{AS-BUILT PLANS}

STATION 690 + 06.00
 REBUILT IN 1999 BY
 STATE OF ILLINOIS
 F.A.I. RTE. 74 SEC. (10-7B) BR
 LOADING HS20 & ALT.
 STR. NO. 010-0028

GENERAL PLAN
 FAI RTE. 74
 OVER SALINE DRAINAGE DITCH
 SEC. (10-7B) BR
 CHAMPAIGN COUNTY
 STR. NOS. 010-0027, 0028
 STA. 690 + 06.00

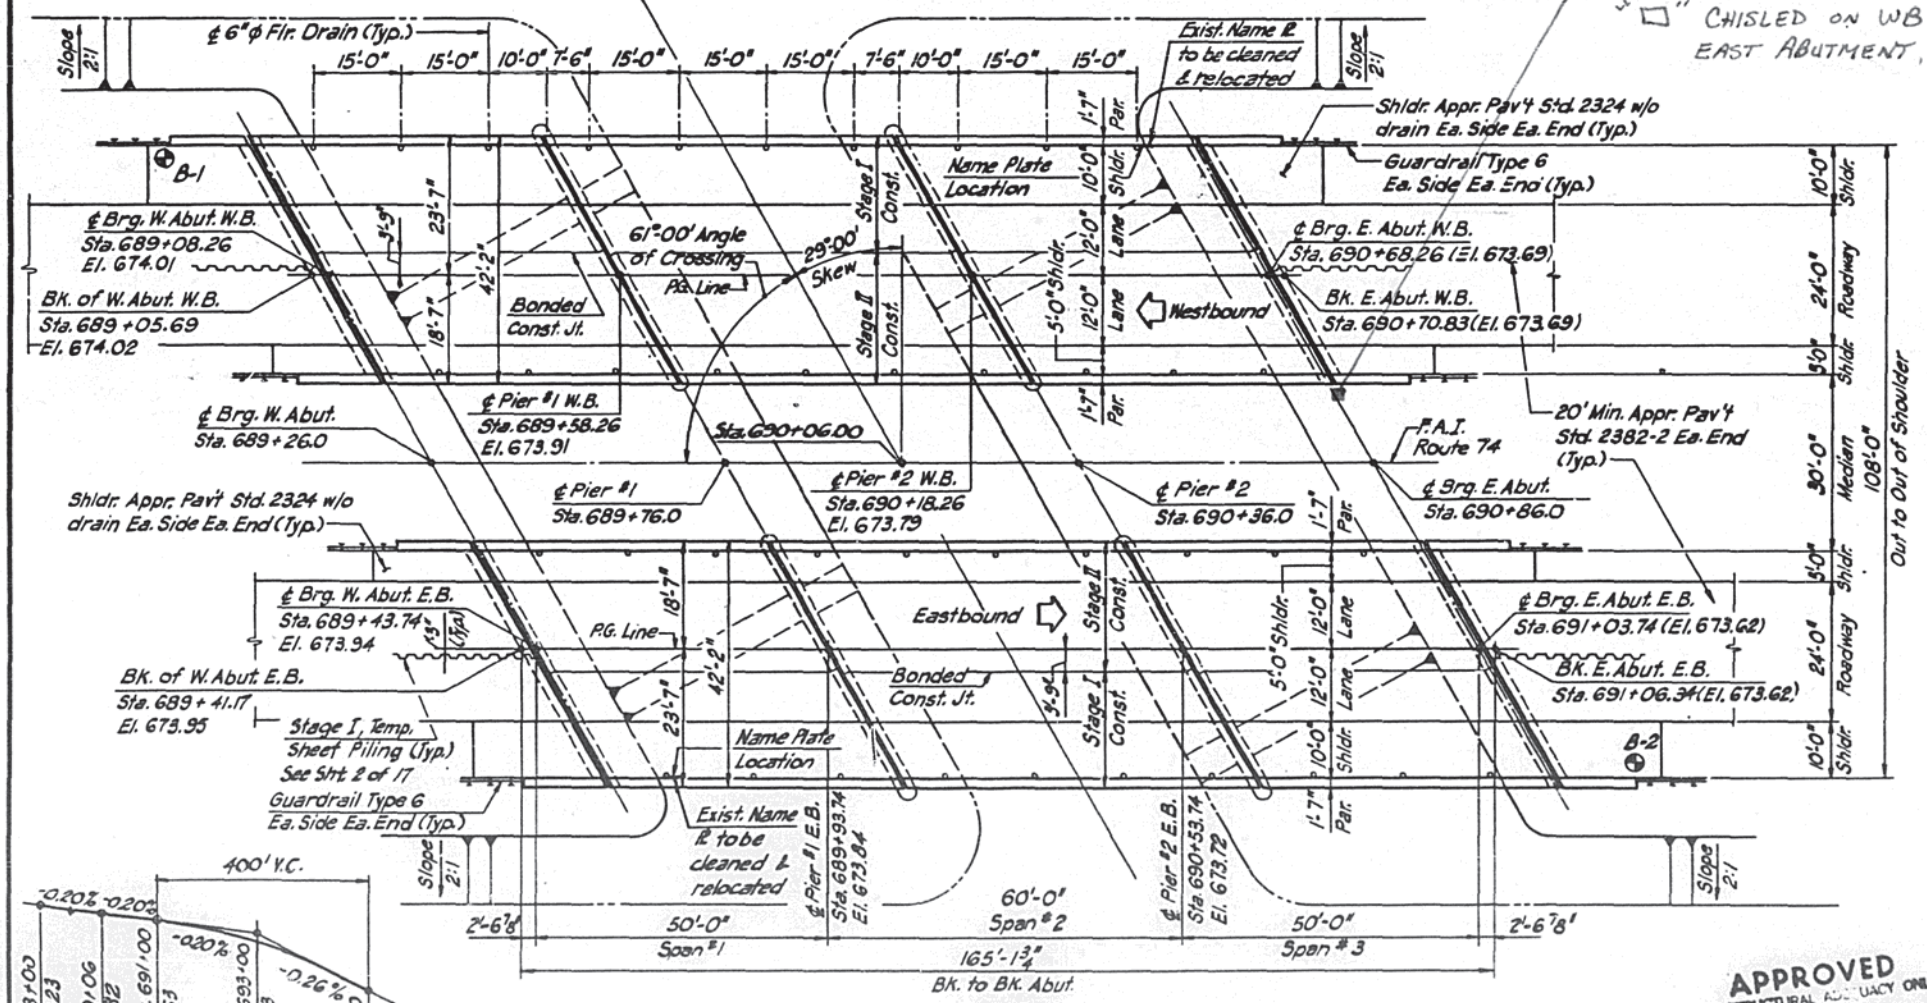
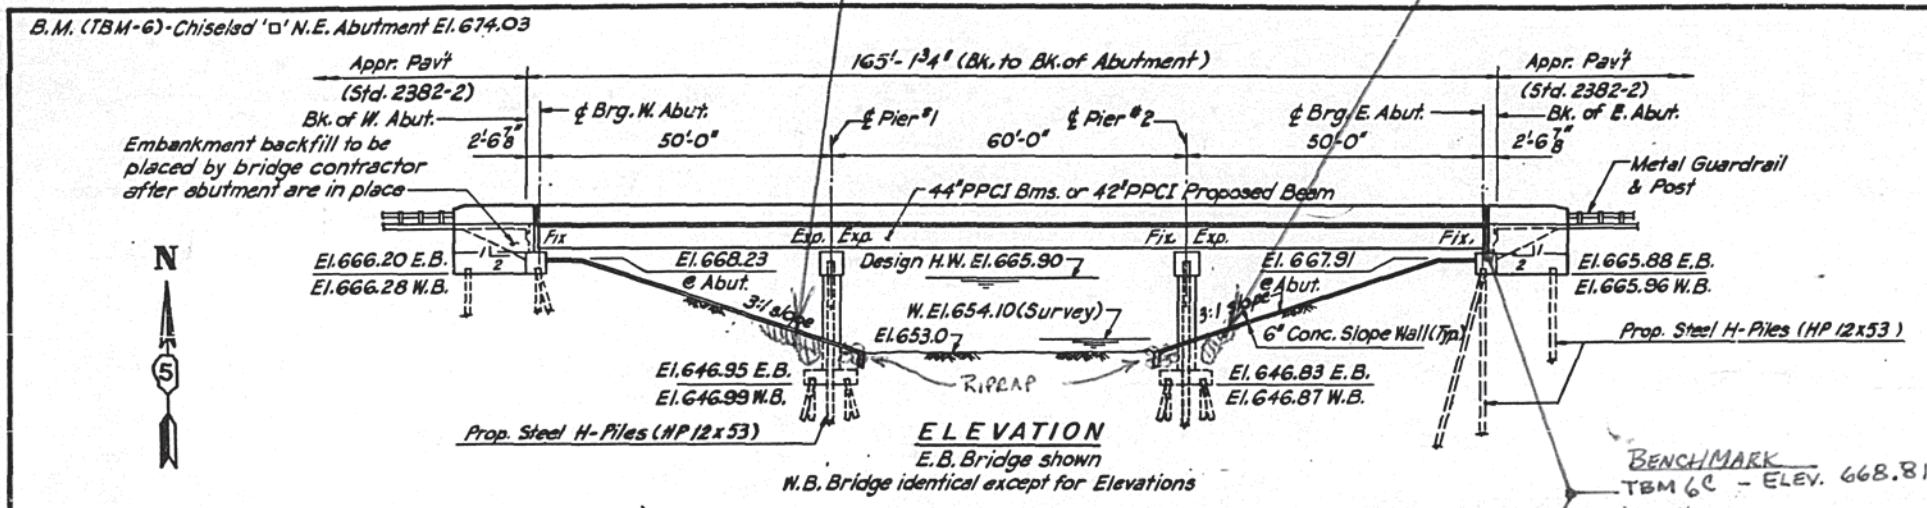
VOIDS UNDER SLOPENALLS WERE FILLED WITH SLURRY MIX CONCRETE

TOP OF SLAB ELEVATIONS
FAI RTE. 74
OVER SALINE DRAINAGE DITCH
SEC. (10-7B) BR
CHAMPAIGN COUNTY
STR. NOS. 010-0027.0028
STA. 690 + 06.00

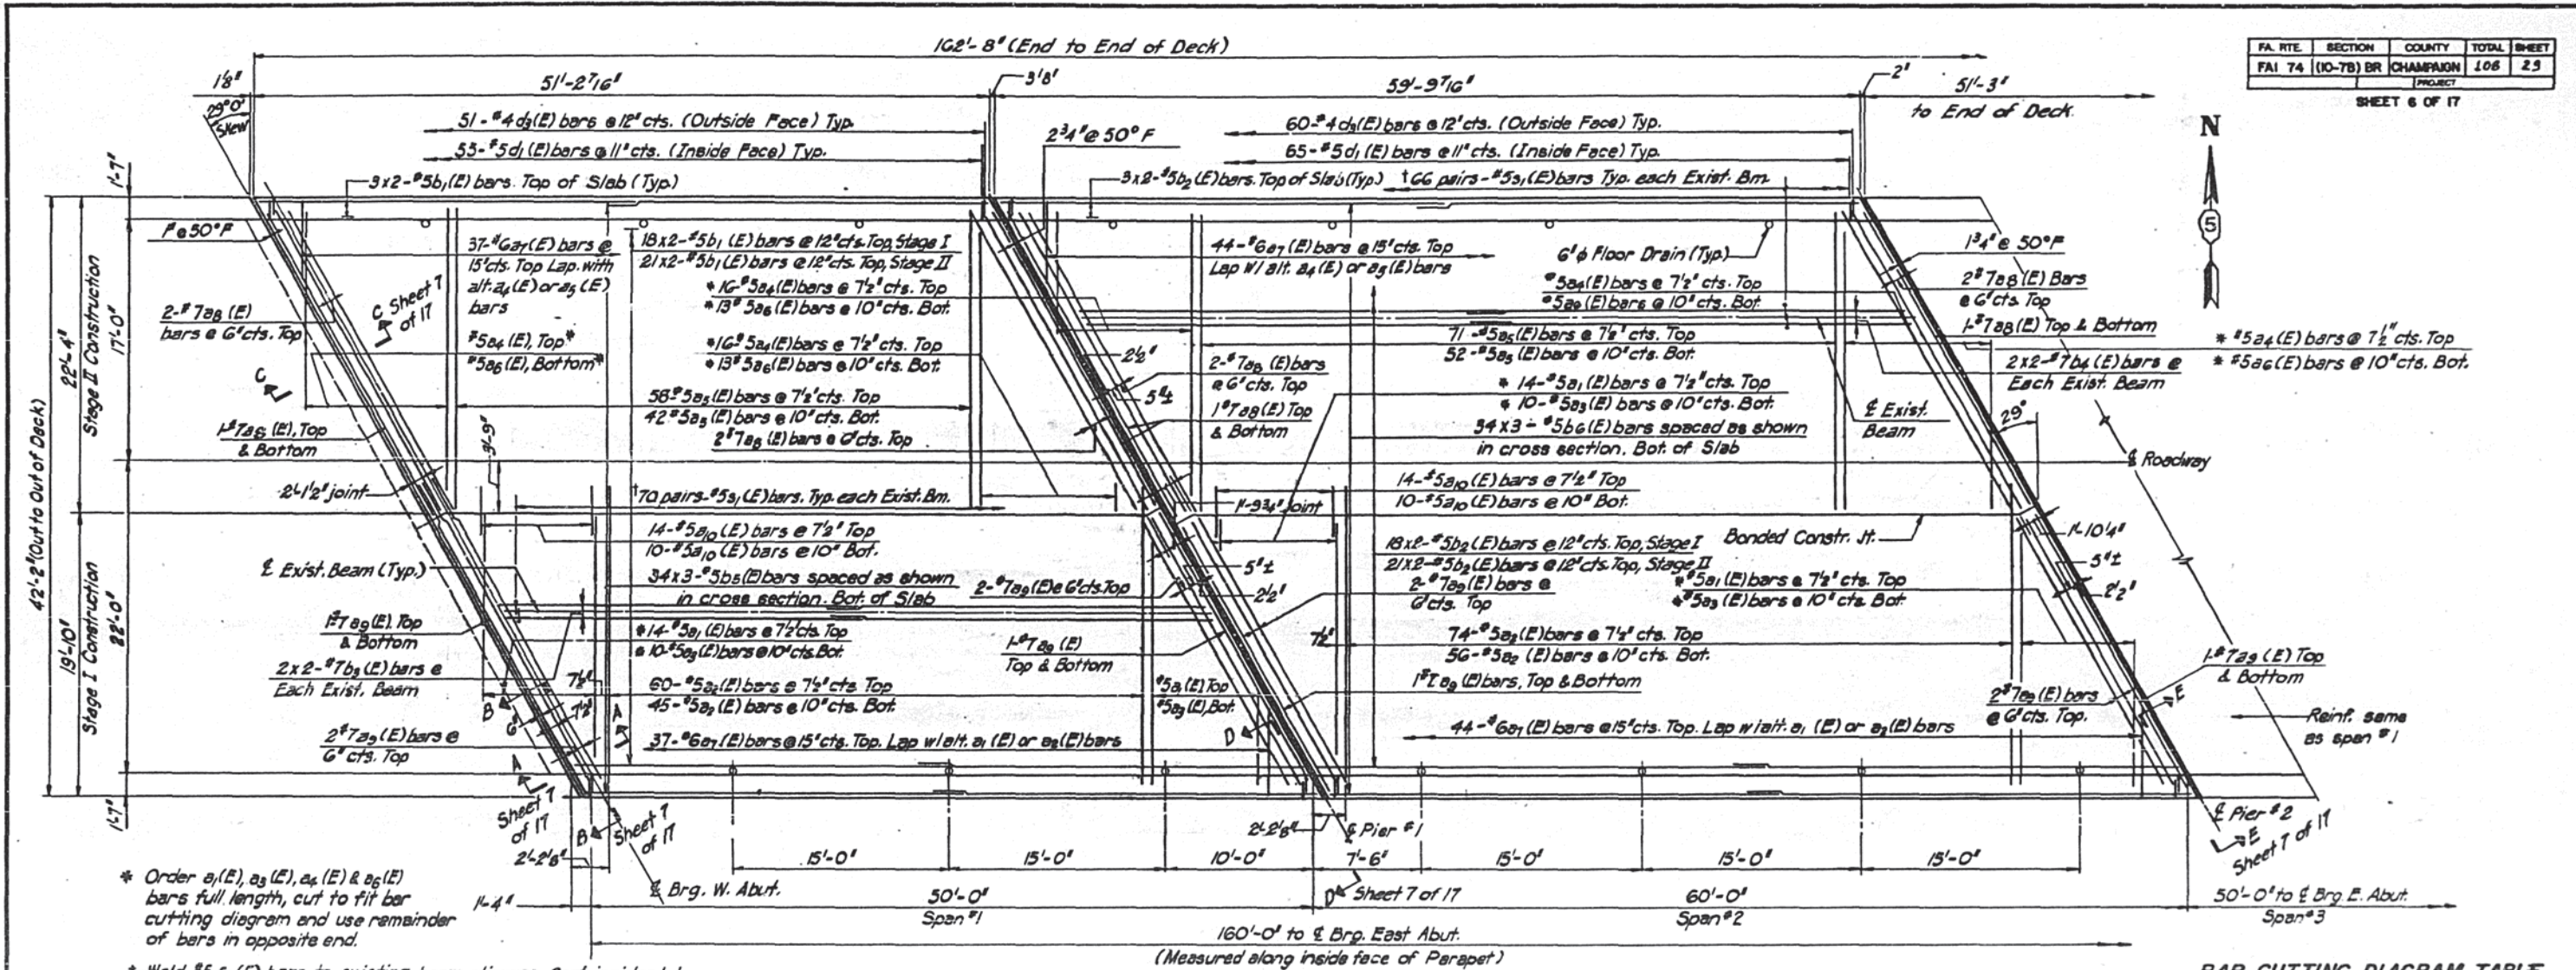
REVISED ELEVATIONS

ABUTMENTS
 FAI RTE. 74
 OVER SALINE DRAINAGE DITCH
 SEC. (10-7B) BR
 CHAMPAIGN COUNTY
 STR. NOS. 010-0027,0028
 STA. 690 + 06.00
 DATE

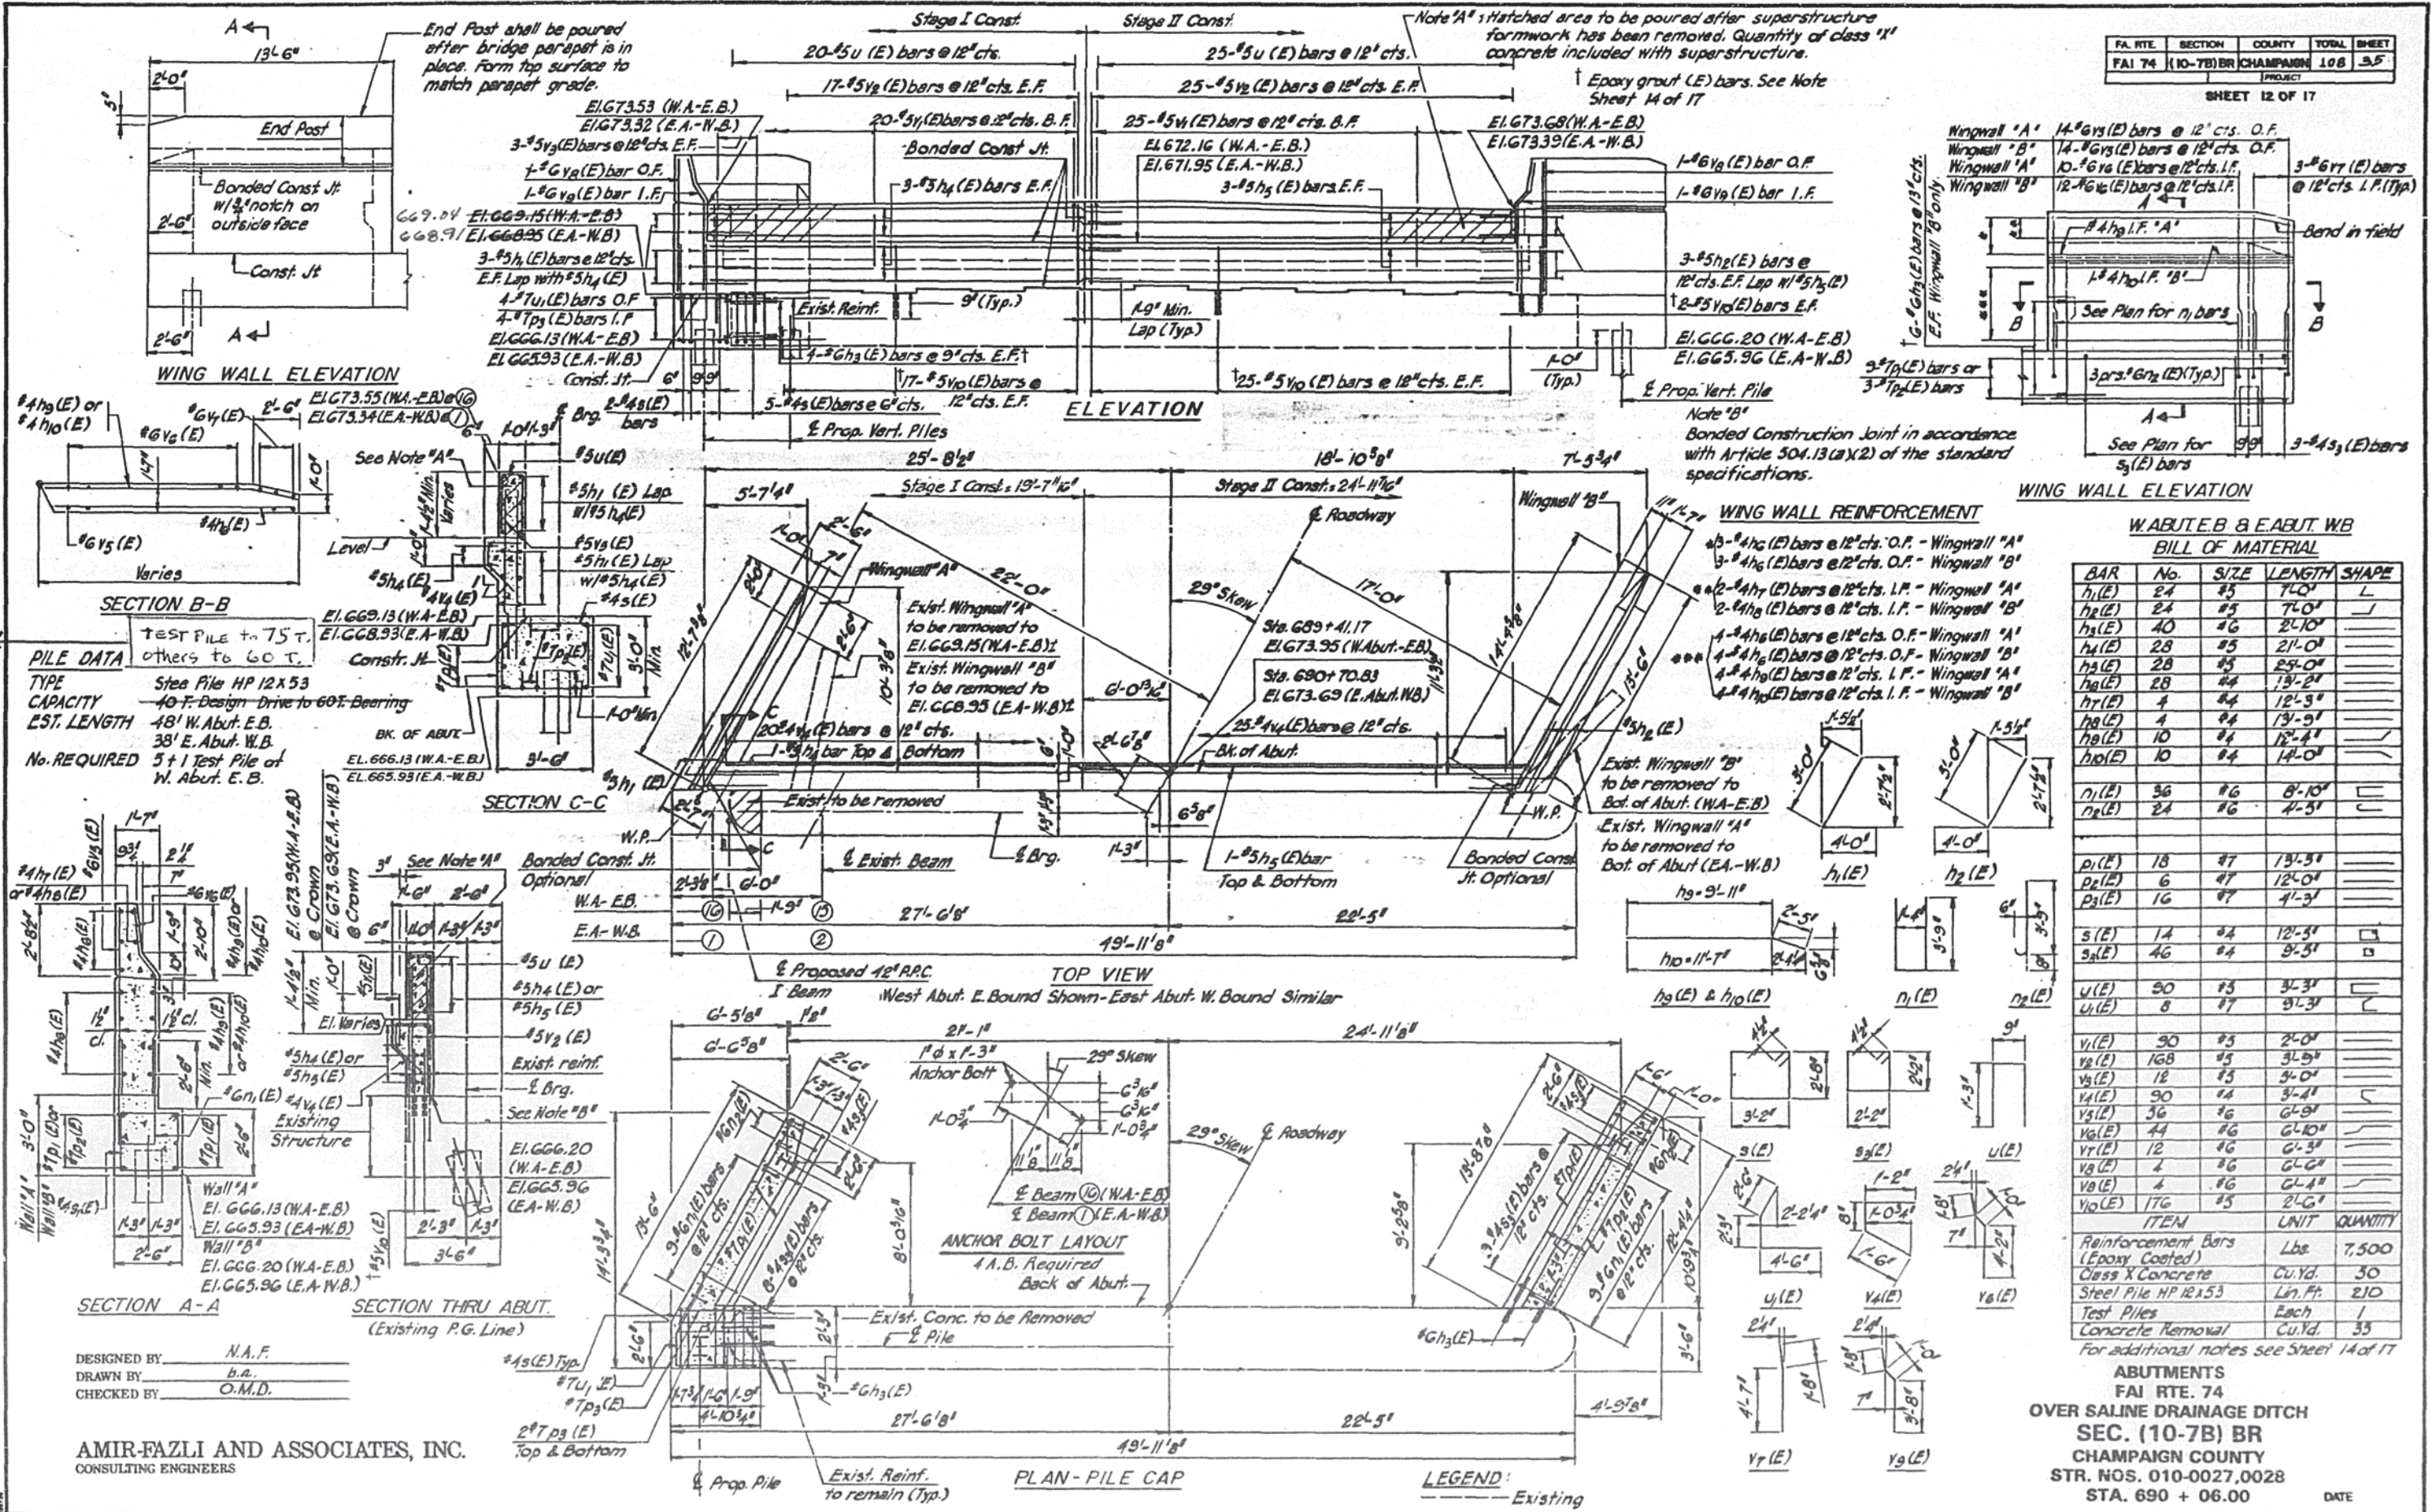
NEW BRG SEAT ELEVS: W. ABUT. -WB → 669.25 ; E. ABUT. -EB → 668.81

← CHANGES MADE DUE TO EFFECT OF BEAM CAMBER

VIA: AL GOODFIELD
 BRIDGE OFFICE, SPRINGFIELD, ILL.
 12-22-92

PIERS
FAI RTE. 74
OVER SALINE DRAINAGE DITCH
SEC. (10-7B) BR
CHAMPAIGN COUNTY
STR. NOS. 010-0027.0028
STA. 690 + 06.00 DATE

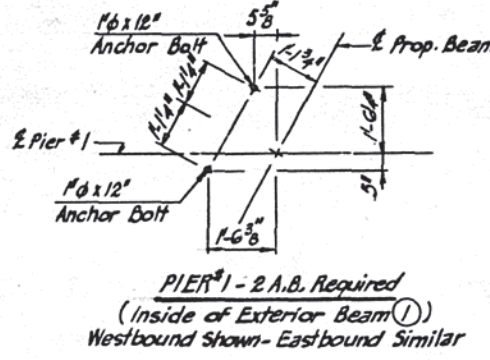
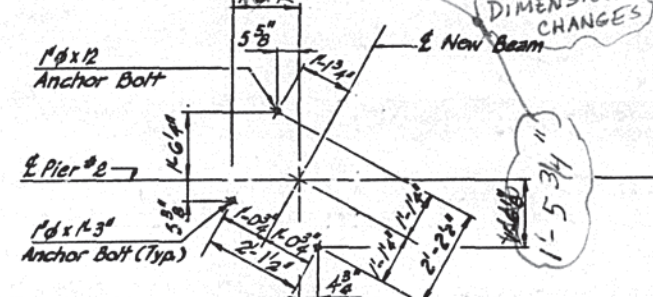
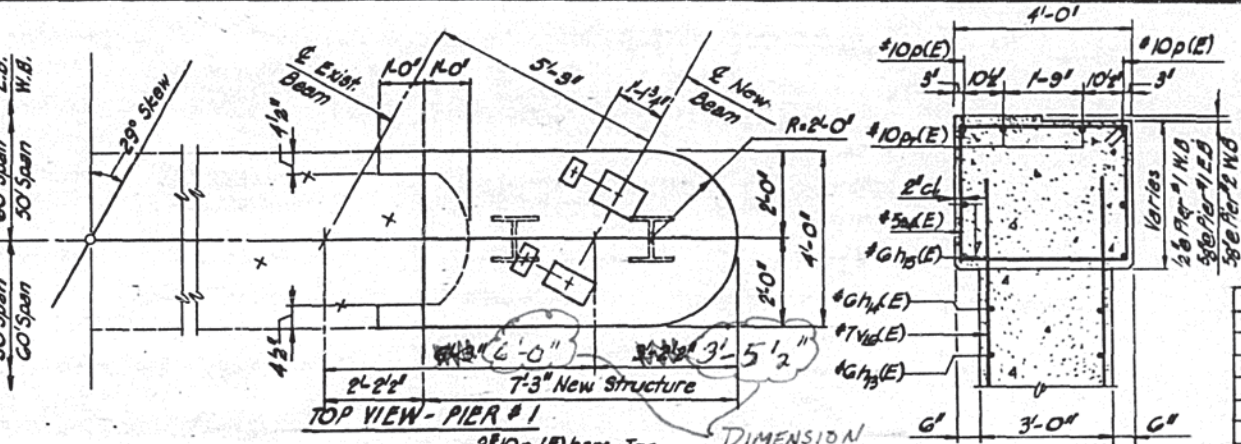
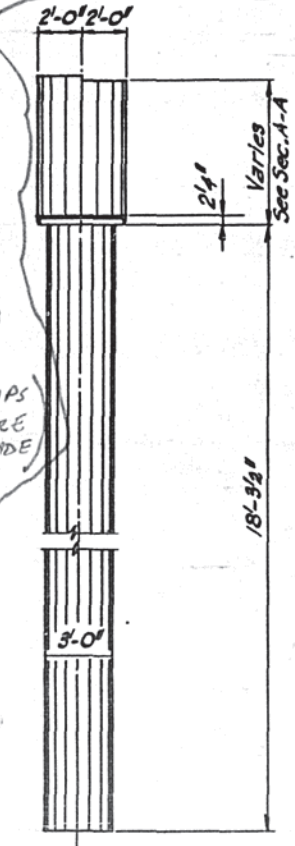
SOME PIER CAP ELEVATIONS WERE CHANGED DURING CONSTRUCTION DUE TO A DESIGNER ERROR IN NOT CALCULATING THE "CAMBER" EFFECT OF BEAMS

DIMENSION CHANGES

NEW PIER CAP ELEVATIONS FROM BRIDGE OFFICE.

PIER 2 WEST-EB → 668.77
PIER 2 EAST-EB → 668.77

(ALL OTHER PIER CAPS WERE BUILT BEFORE BRIDGE OFFICE MADE CHANGES)

AL GOODFIELD BRIDGE OFFICE, SPRINGFIELD, IL. 12-22-92
